Subject: Revised Request for Modification of the Phased Section 404 Individual Permit and Section 401 Individual Water Quality Certification for the construction of the Triangle Expressway Southeast Extension from NC-55 Bypass in Apex to I-40, Wake and Johnston Counties. TIP Nos. R-2721, R-2828, and R-2829. Federal Aid Project No. 0540047.

We are requesting a modification to the Section 404 Authorization (SAW-2019-02240) and the associated 401 Water Quality Certification (Permit No. 20181249). This request is necessary due

Revised Table 5. R-2829A Jurisdictional Resources Impacts

SITE 3

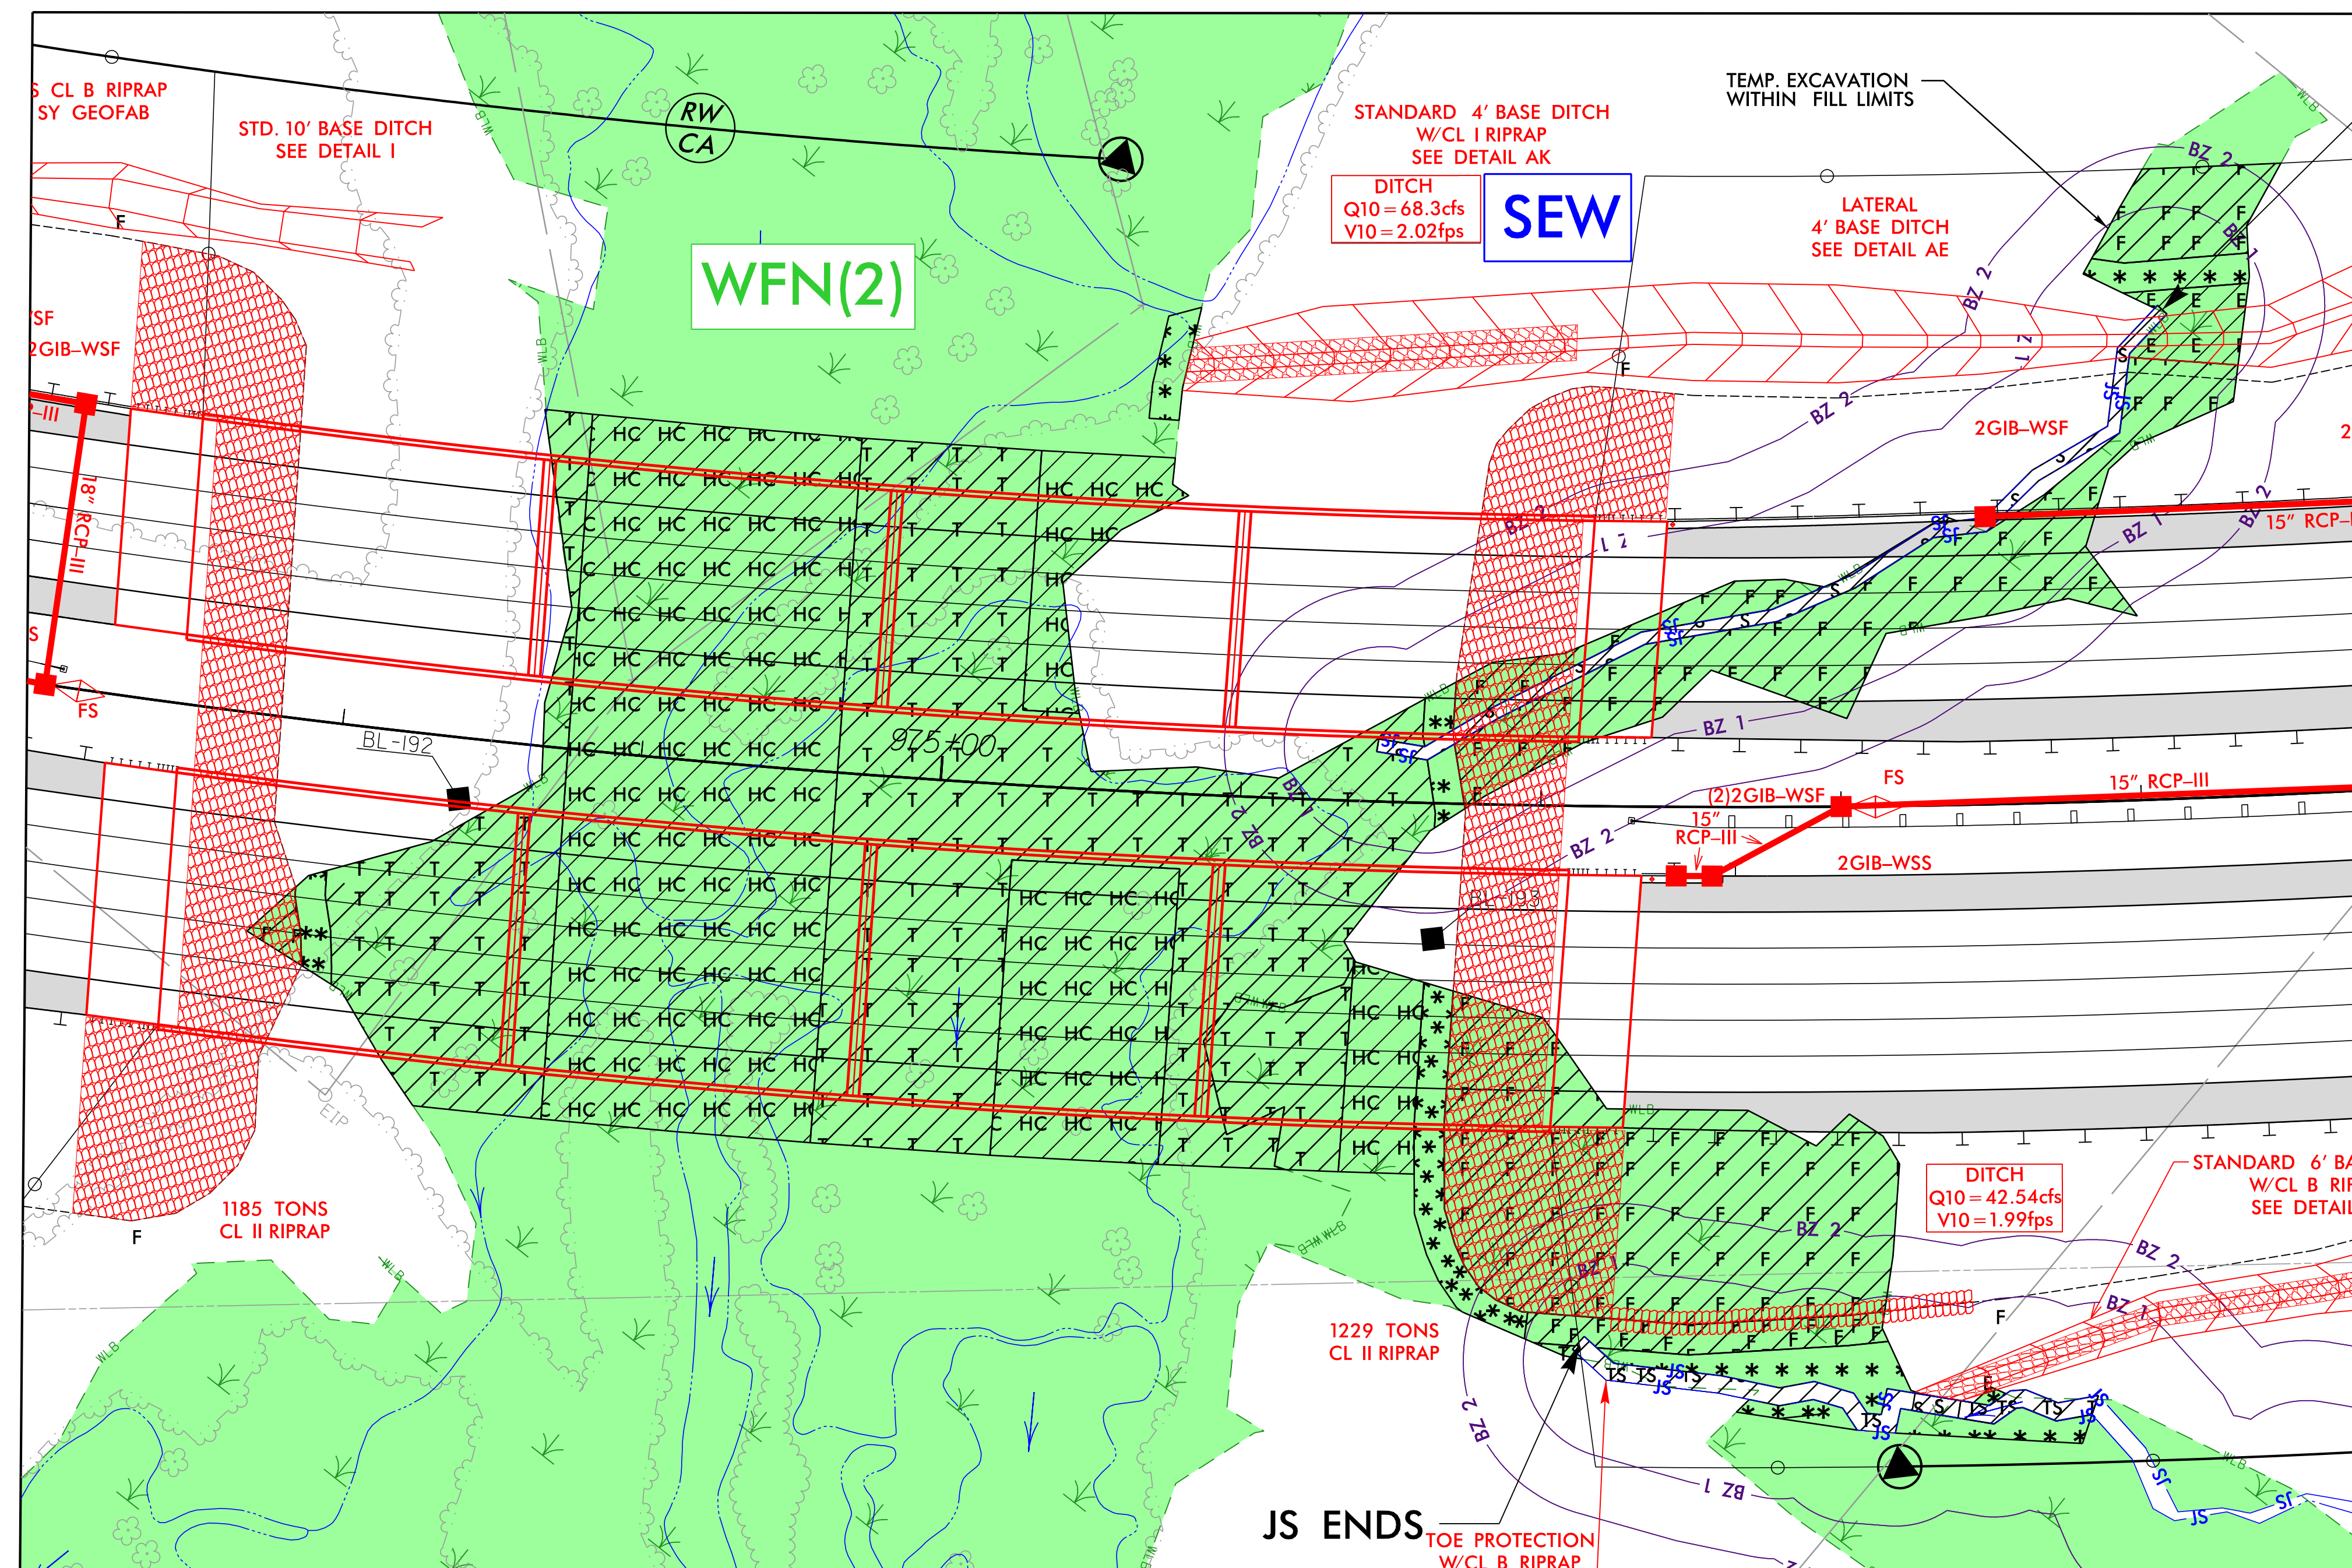
- Permanent wetland fill: 0.284 ac (previously 0.257 ac, increase of 0.027 ac)
- Mechanized clearing in wetlands: 0.071 ac (previously 0.098 ac, decrease of 0.027 acre)

Roadway Site 3

Stream SEY comes onto the project and stops at the Bushy Branch wetlands and bridge end bent on -L- RT. This stream is a low, flat area and is undefined as it travels into the wetlands. Per recent field reviews, it was determined that additional toe protection rock shall be installed along the new bridge end bent toe of slope for stabilization of this low-lying area. This rock installation required the mechanized clearing limits surrounding the toe of slope to be revised to permanent fill in wetland impacts.

SITE 12

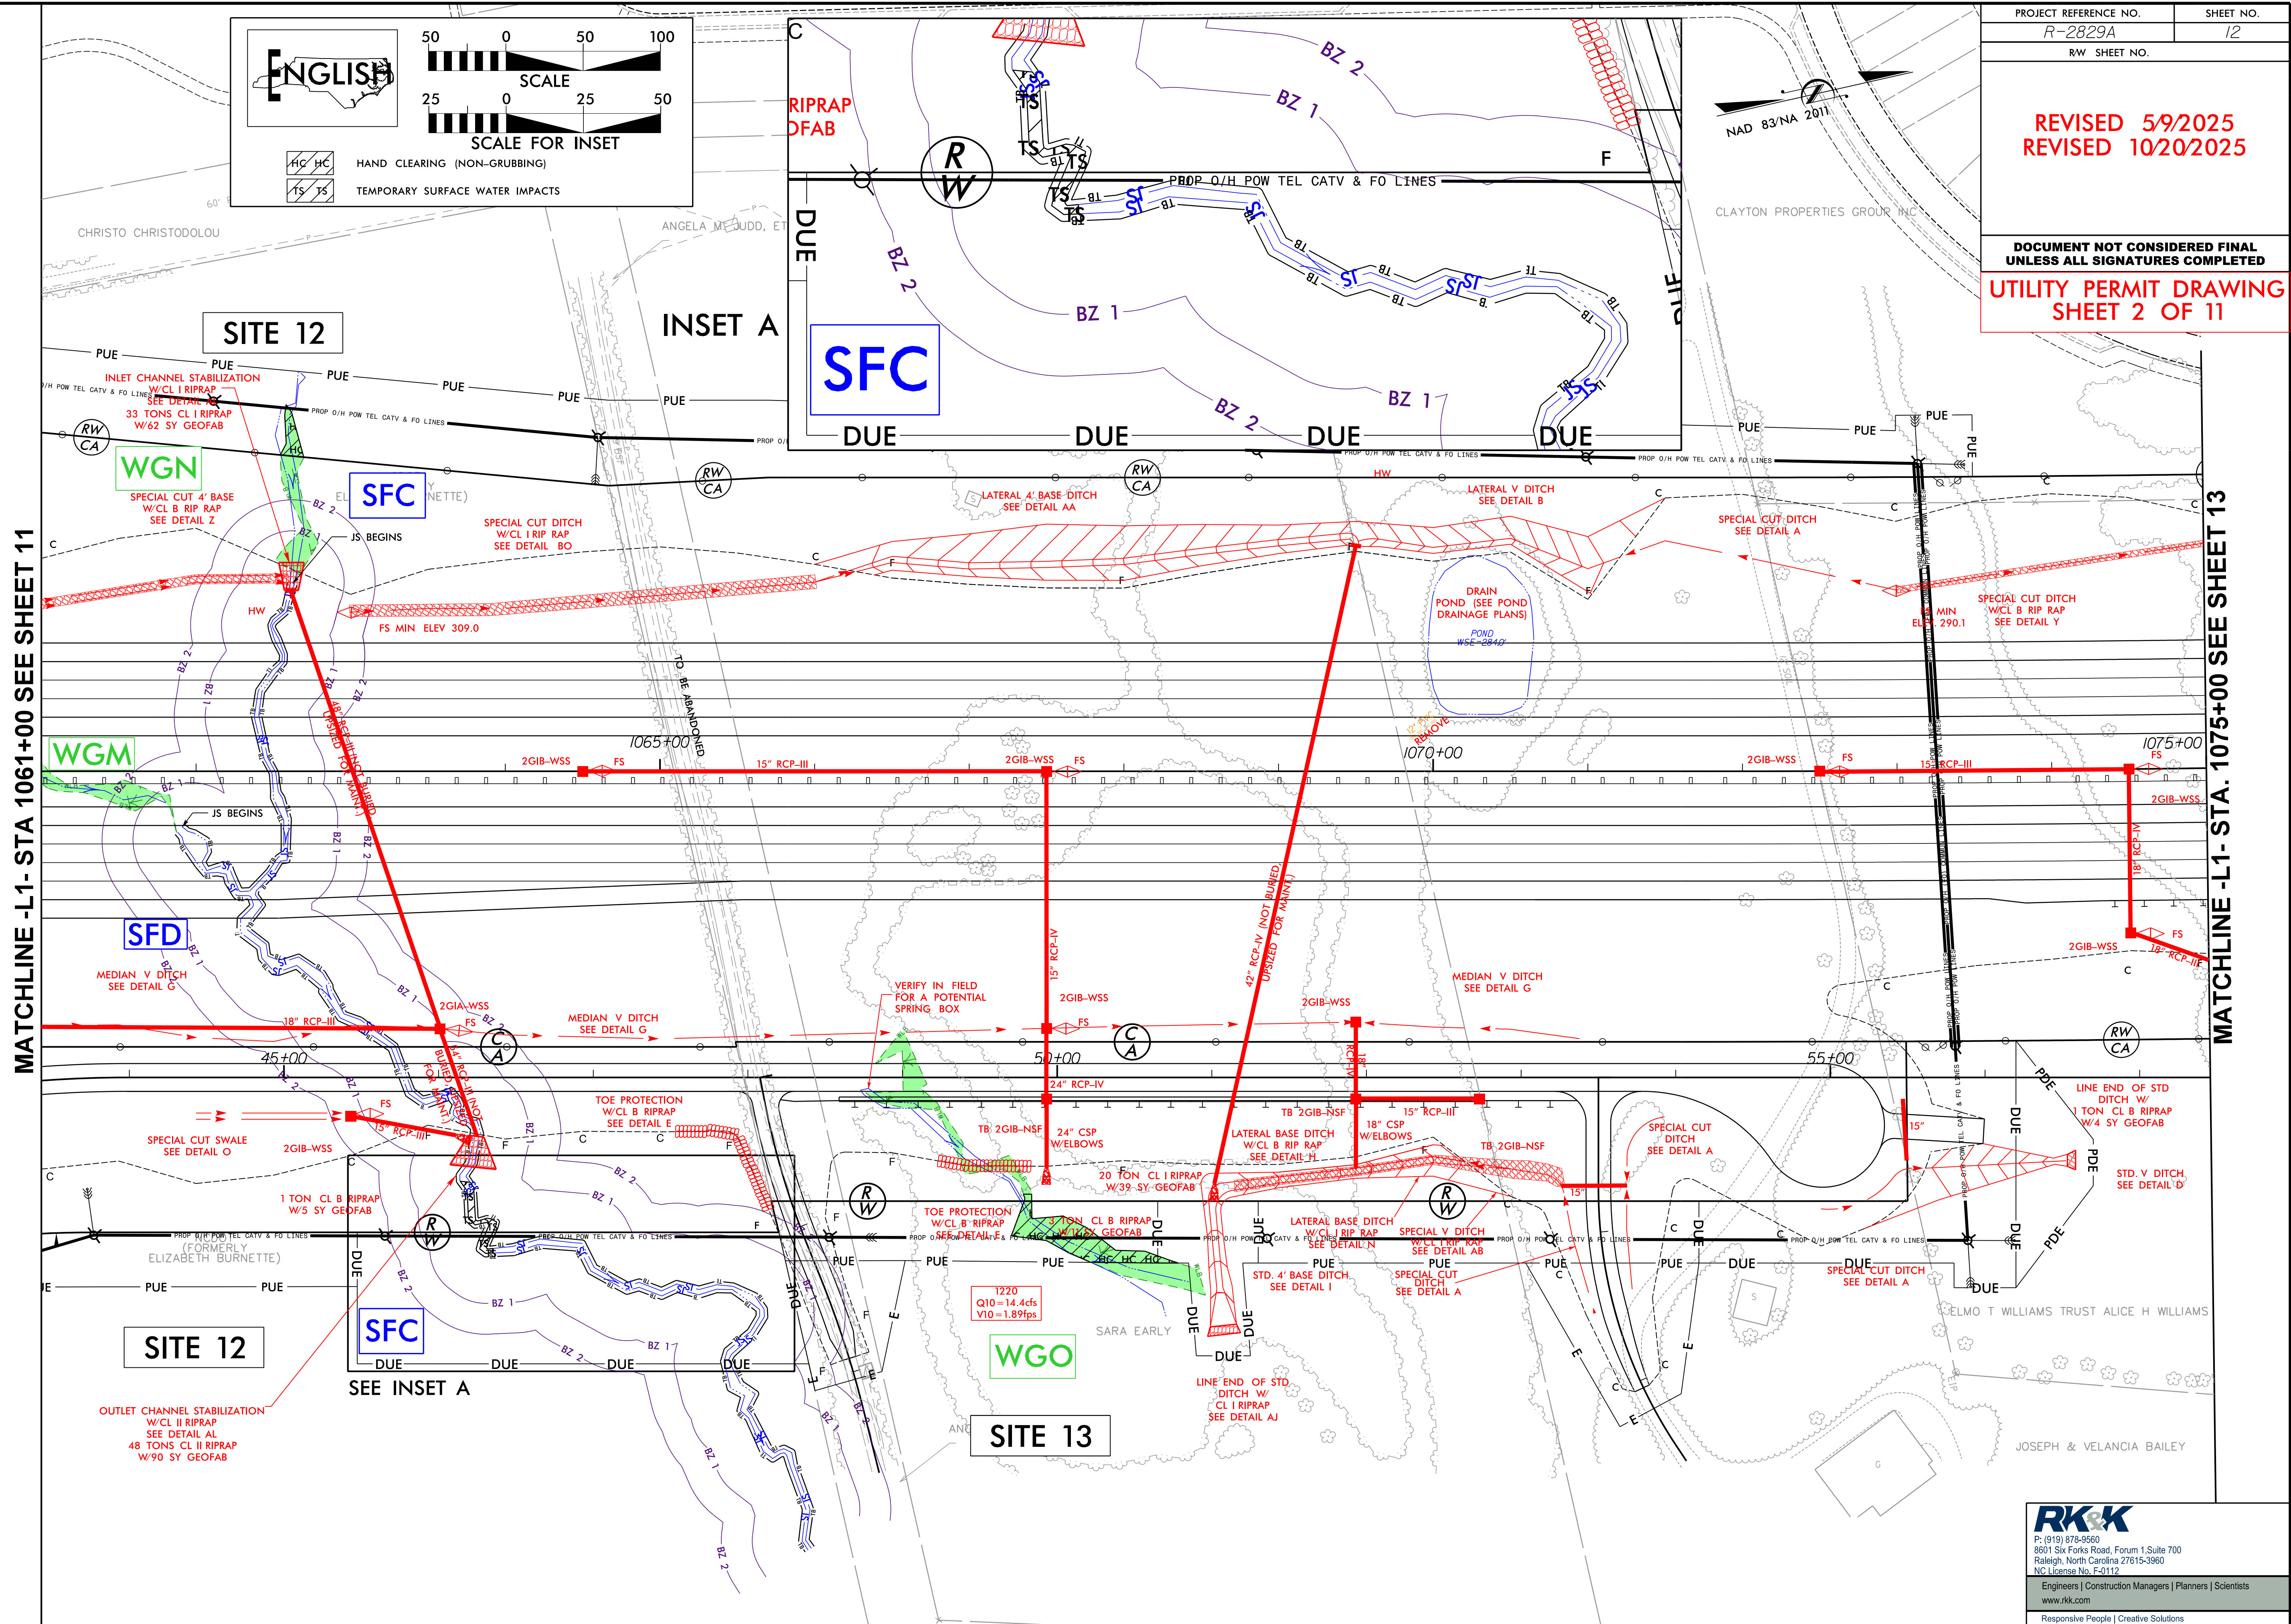
- Hand clearing in wetlands: 0.006 ac (previously 0.000 ac, increase of 0.006 ac)
- Temporary stream fill: 65 LF (previously 48 LF, increase of 17 LF)

Utility Site 12

Duke Energy (overhead) power lines will be relocated within an easement that will be shared with Spectrum (overhead) and AT&T (overhead) and MCI/Verizon (overhead), requiring hand clearing within wetland WGN, resulting in unavoidable impacts. Additionally, 65 linear feet of temporary fill within stream SFC will be needed for installation of the utilities to support construction access. No additional impacts to streams or riparian buffers will occur at this location.
